**RE: Northern Pulp Nova Scotia - Environmental Assessment Focus Report - Replacement Effluent Treatment Facility**

**RE: Northern Pulp Nova Scotia Focus Report**

## **RE: Previous Submission Environmental Assessment**

**Figure 2: Ice Gouging along a small section of the Proposed Route (P.104, Appendix 2.2)**

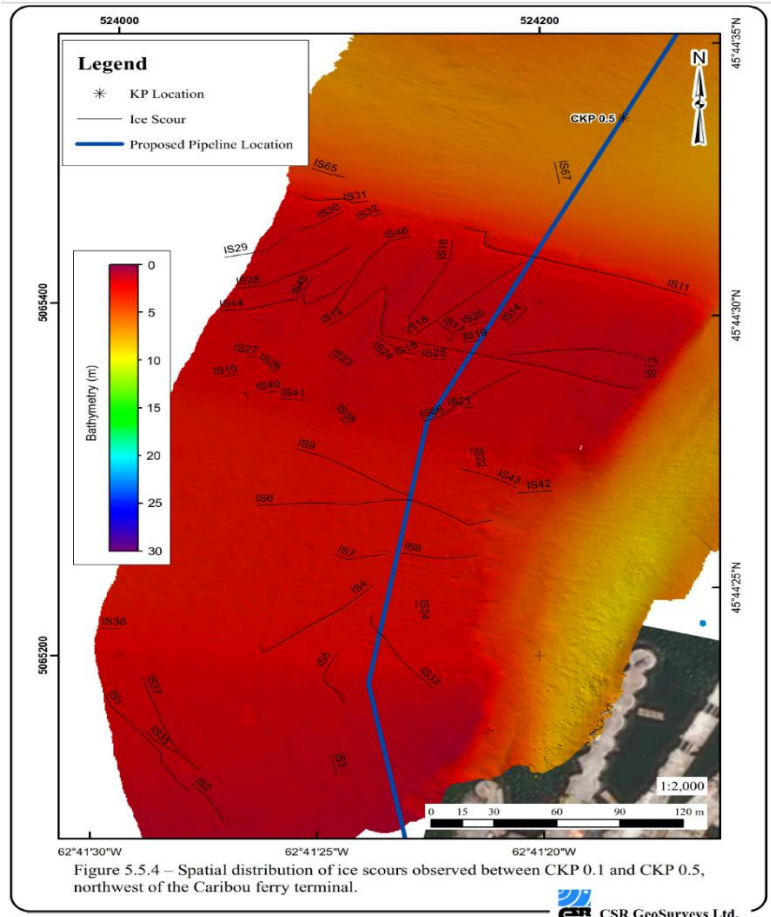
The new data obtained as part of Northern Pulp's Focus report has verified the soft sandy soil conditions and found extremely alarming rates of ice scouring directly along the proposed route. The report has also confirmed extensive ice grounding located along the shallow area in Figure 1 (Figure 2 of previous submission). Due to the predominately sandy soil along the proposed route, all of the depths of scouring obtained are subject to some degree of error, as the soil quickly infills the scouring. CSR states that all scouring was from the 2018-2019 winter, as can be expected due to quickly changing sandy bottom continuously subject to tidal and wave action. The question is how much infill had taken place from the time the ice left until the survey was completed?

Figure 2 is one of many figures in CSR's report depicting the ice gouge locations along the proposed route. The blue line shows the proposed pipeline route while the several black lines show ice gouges found by CSR's survey. The figure illustrates a portion of the pipe route where depths are as shallow as 1 meter. This figure along with many others are severally alarming when looking at the possibility of ice impact on the pipe. Considering that founded gouges have measured lengths of up to 260 meters and widths of up to 6 meters, this data is not something to take lightly. If there is any amount of error in forecasting the maximum depth of ice gauging there is a large possibility of ductile pipe failure due to direct impact with catastrophic repercussion to the surrounding marine environment.

**Figure 1: Observed deformations of installed HDPE pipelines (Motahari & Abolmaali, 2010)**

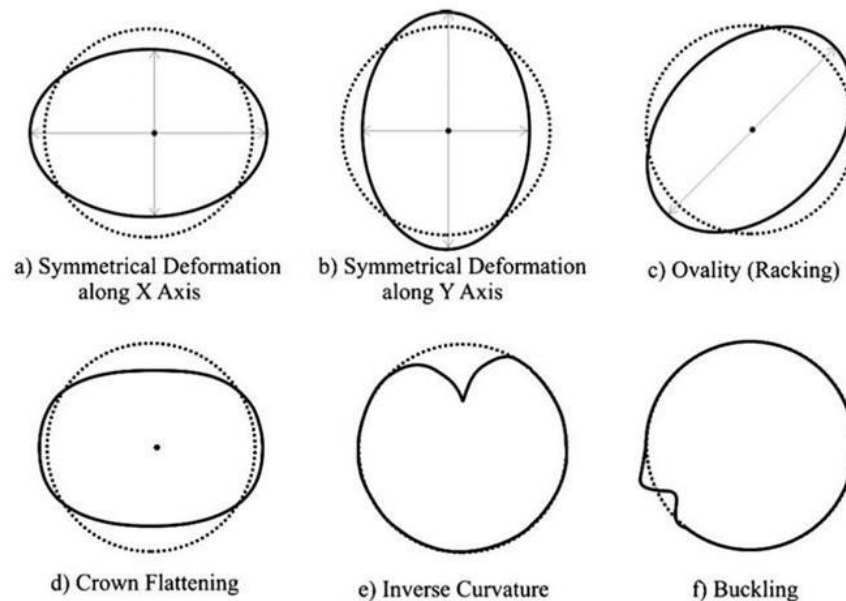
geometric stability is eventually lost and the crown of the pipe will begin to flatten and eventually reverse leading to reverse curvature collapse of the pipe Figure 1 shows observed pipe deformation patterns that lead to failure due to increased pipe deflections (Plastic Pipe Institute, 2014).

Figure 1 is from a study published in the Journal of Transportation Engineers of the American Society of Civil Engineers (ASCE). The study included structural monitoring with video and laser surveillance of over 15,000ft (96 pipelines) of buried HDPE pipe across the USA. It was concluded that the majority of pipelines had actual deformations in excess of design code limits (Motahari & Abolmaali, 2010). This study gives great insight into the possible repercussions of not accurately modeling induced strains in buried HDPE pipes.
